REQUEST FOR COUNCIL ACTION

AGENDA SECTION: PUBLIC HEARINGS – Continued Item	ORIGINATING DEPT: PLANNING	ITEM NO. E-1
ITEM DESCRIPTION: Land Subdivision Permit (Preliminary Plat) #03-19 by Badger Hills LLC to be known as Badger Hills Subdivision. The Plat proposes to subdivide 79.50 acres of land into 171 lots for residential development and 5 outlots. The plat also proposes right-of-way dedication for public roadways. The applicant is also requesting approval of a <i>Substantial Land Alteration</i> to permit site grading that will modify grades by more than 10 feet on portions of the property. The applicant is also requesting Design Modification #03-12 to the requirements of Chapter 64 of the <u>Rochester Zoning Ordinance and Land Development Manual</u> to not provide mid-block pedestrian connections and the pedestrian facilities on both sides of the proposed 41 st Street NW as required in Section 64.227. The property is located along the north side of Valley High Road NW, west of West Circle Drive and east of 50 th Ave. NW.		PREPARED BY: Theresa Fogarty, Planner

PRELIMINARY PLAT

Preliminary Plat #03-19
Badger Hills Subdivision
1,400' Notification Distance
Ward 3 McConnell
06/17/

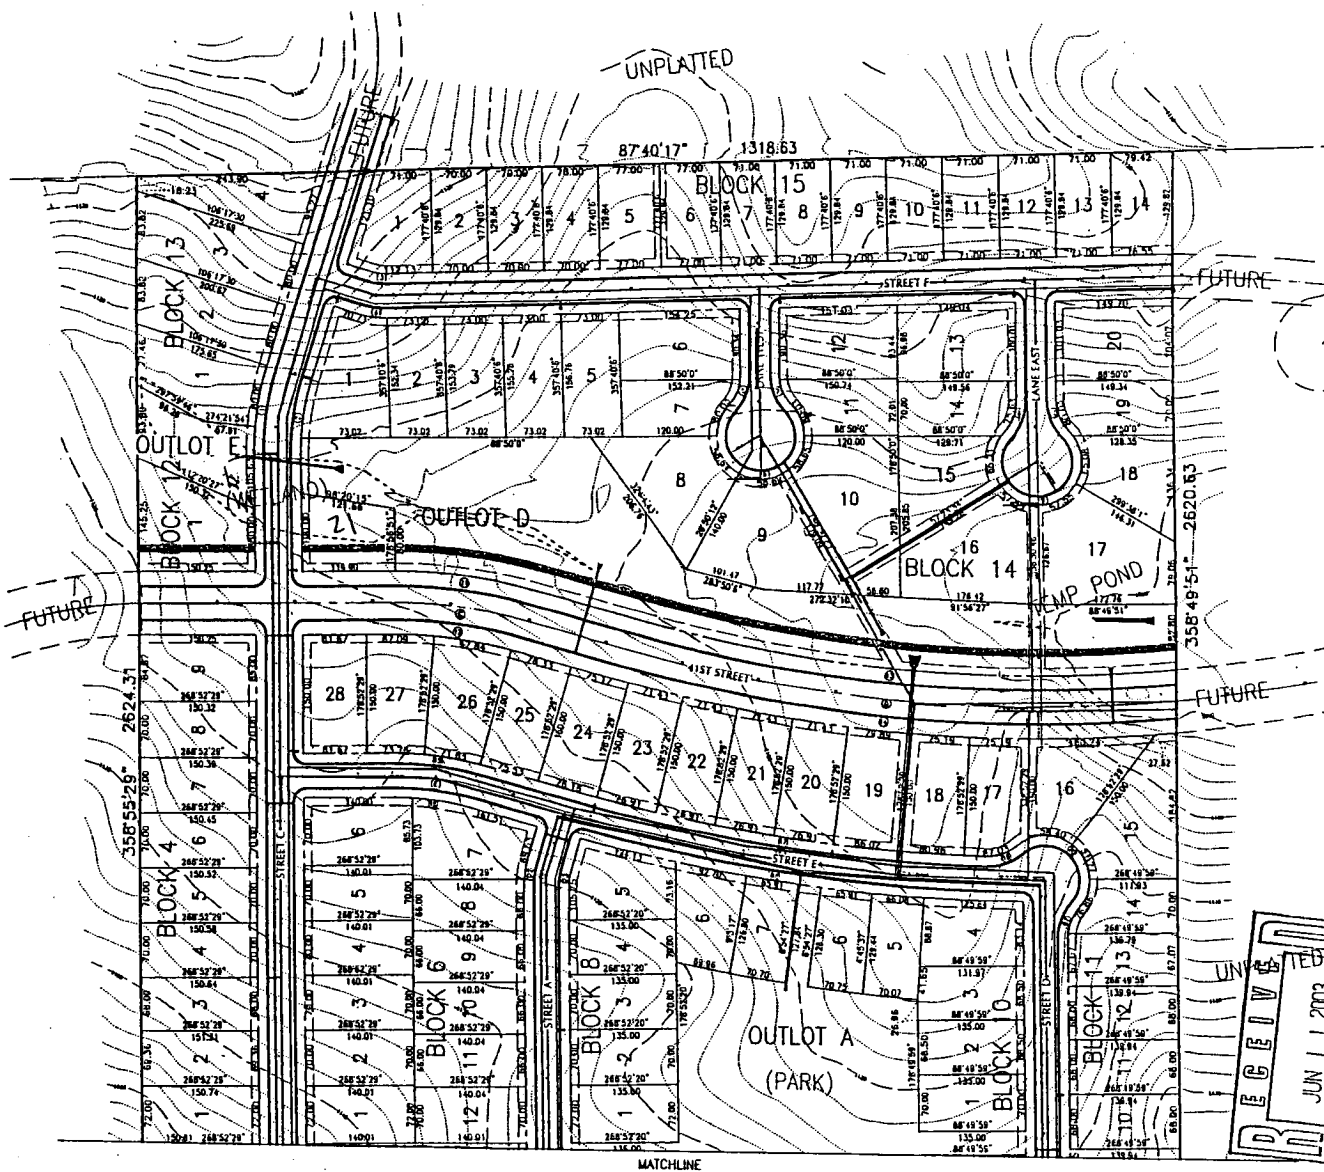
1. *The Plat shall be revised.*

- a. *Adding the directional of NW to 41 Street so it reads "41 Street NW".*
- b. *Coordinating with the Planning Department – GIS Division, numbering or naming all other roadways within this plat.*
- c. *The location map on the face of the plat shall be changed to Cascade Township coordinates T107N. Currently location map indicates Rochester Township coordinates T106N.*
- d. *Providing an additional utility easement along the south lot lines of Lot 1, Block 1 and Lot 1, Block 2, as requested by Rochester Public Utility Water Division Memorandum, dated June 18, 2003 and Operations Division Memorandum, dated June 17, 2003.*
- e. *Dedicating a 30' wide outlot mid-block connection in the vicinity of ~~Lots 7 & 8 of Block 15, and two 30' wide outlot midblock connections in the vicinity of Lots 9 & 10 and Lots 19 and 20 of Block 11.~~*

f. *Indicating controlled access along the entire frontage of Valleyhigh Drive NW, with the exception of any approved street accesses. Additional controlled access is required within 250 feet of the right-of-way intersection of Valleyhigh Road NW and Avenue "A" and along the entire frontage of 41 Street NW.*

~~g. *Dedicating a public pedestrian facility easement, of sufficient width to accommodate construction and maintenance of said facilities, at no cost to the City for the pedestrian paths along 41st Street NW and Valleyhigh Road NW as shown on the preliminary plat outside of the right-of-way.*~~

h. Dedicate Outlots D & E and 20 additional feet of right-of-way for 41st Street NW along the south side of Lot 1, Block 12 and Lot 21, Block 14

BADGER HILLS SUBDIVISION
ROCHESTER, MN
SUBSTANTIAL LAND ALTERATION

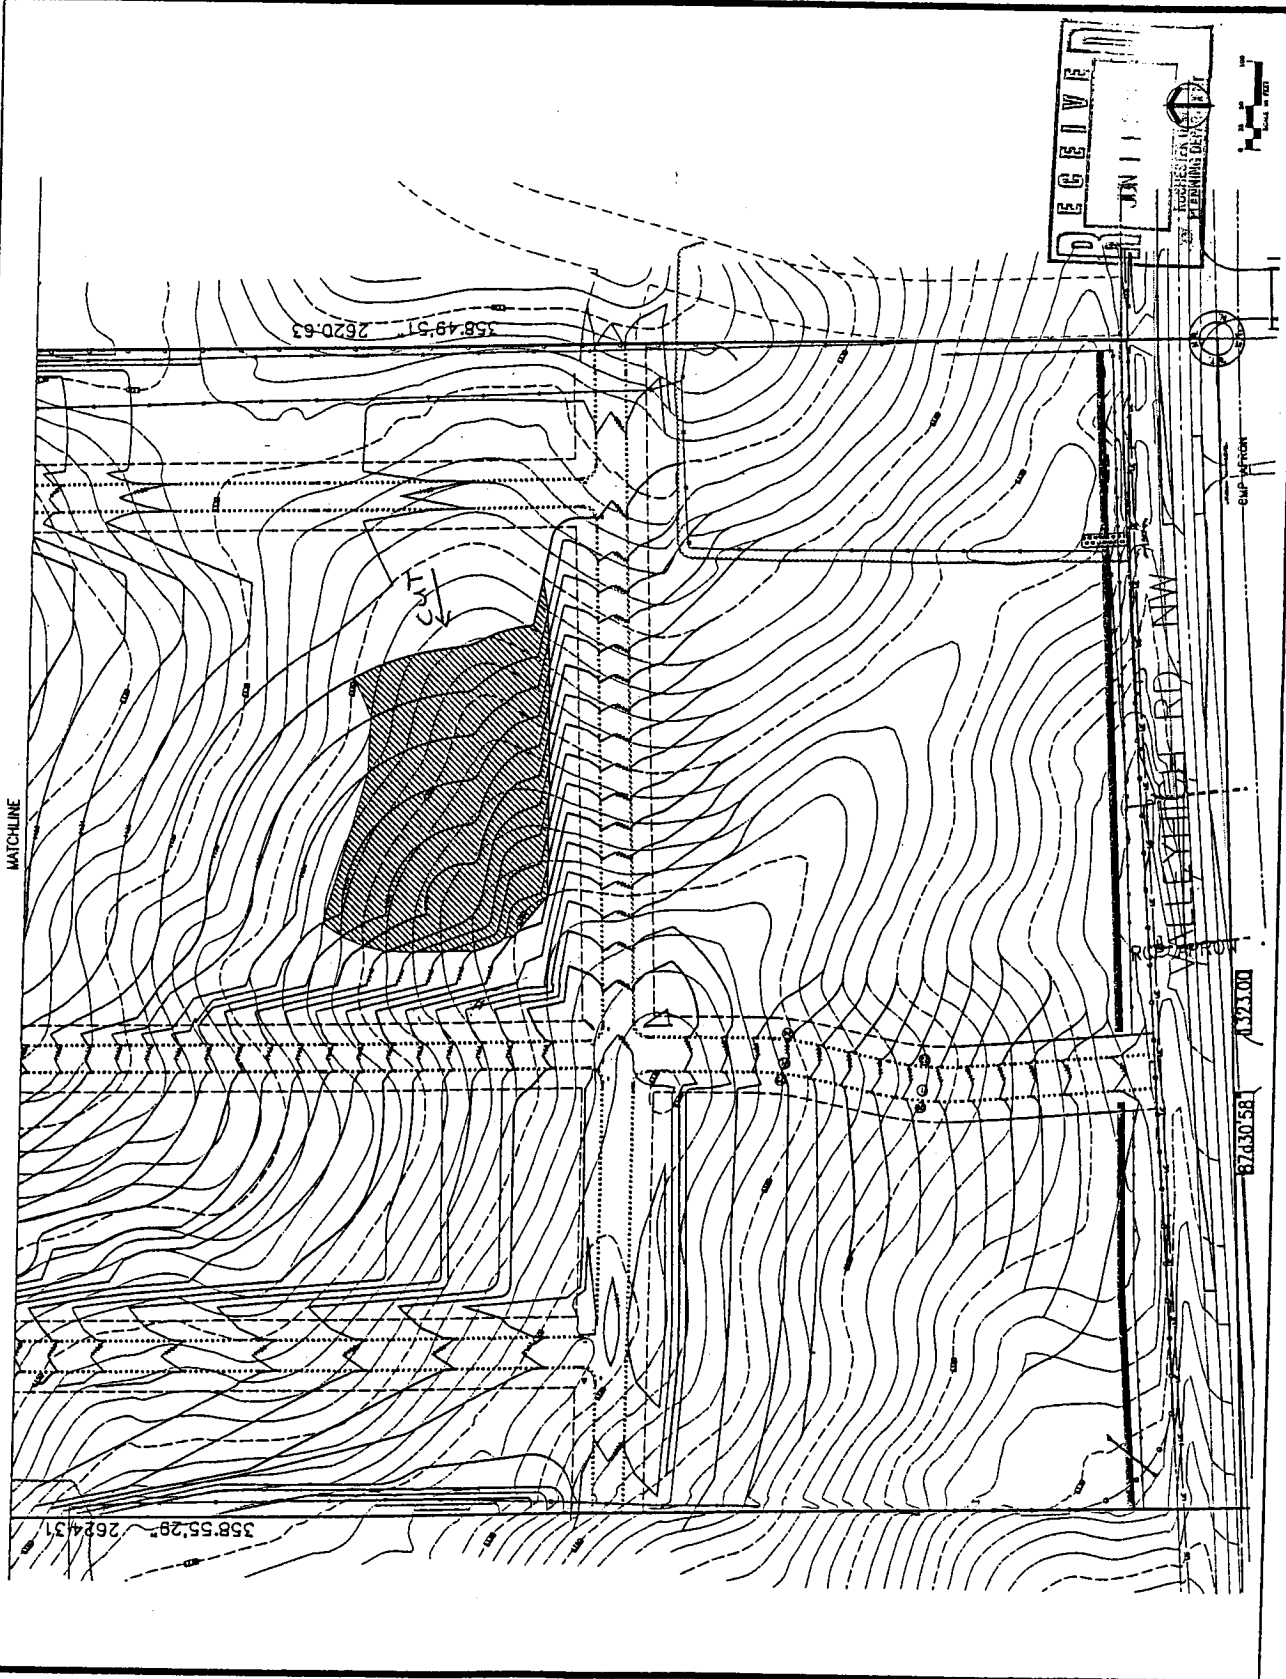
This development includes a proposal for cut and fill work which involves a grade change of 10-feet or more from the pre-existing grades. The approximate area where the grade is proposed to be changed, Block 7, Lots 1-5, Block 9, Lot 1 and outlot A will be cut and Block 12, Lot 1, Block 13, Lot 1, Block 14, Lots 1-11 & Lots 15-20 and Outlot E will be filled.

- 1) The activity should not result in danger to life or property. Generally, the top of the existing hill will be regarded to be suitable for residential uses. The grading and drainage plans will need to comply with City standards and be approved by the Rochester Public Works Department.

- 2) The grading plan for this project needs to be approved by the Rochester Public Works Department and it will document the extent of the work. All cut material will be used to level area within this plat to more suitable grades for residential uses. Noise and dust control will need to comply with City standards.
